SERVICE BULLETIN

PURPOSE : INFORMATION	ISSUE NO. : MSB-13EXL54-001	DATE : 2013-06-10
SUBJECT : ABOLITION OF CLIPS FOR INSTALLATION OF BREATHER HOSE		<Destination/Model> (EUR/MMAL/NZ) OUTLANDER PHEV <M/Y> 14
GROUP : POWER UNIT & BATTERY FOR DRIVE(Gr.54D)

GENERATOR

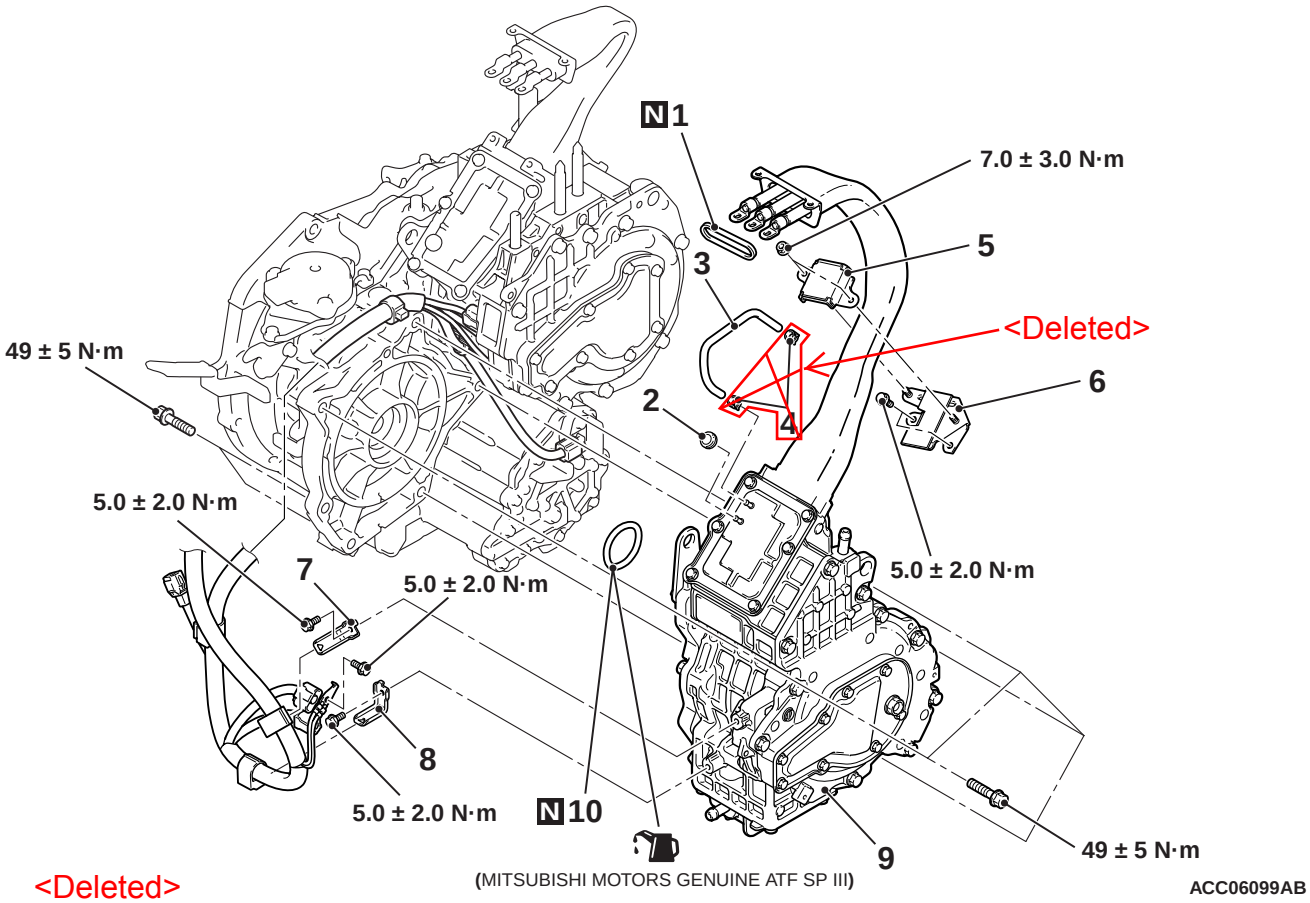
<Deleted>

1. O-ring
2. Breather nipple
3. BREATHER HOSE
>>A<< 4. Clip
5. Front motor (electric motor unit) cable upper bracket
6. Front motor (electric motor unit) cable lower bracket
7. Wiring harness bracket
8. Wiring harness bracket
9. Generator
10. O-ring

>>A<< CLIP INSTALLATION

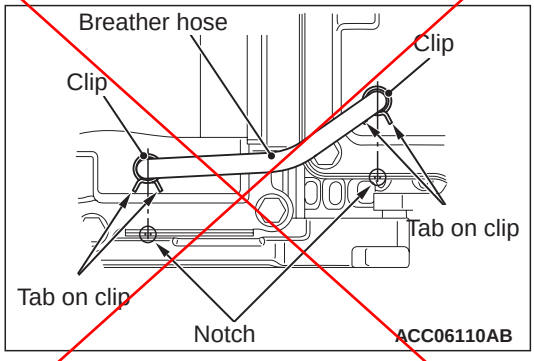
<Deleted>

The tabs of the clips should face towards the notches on the rear motor and the generator as shown.
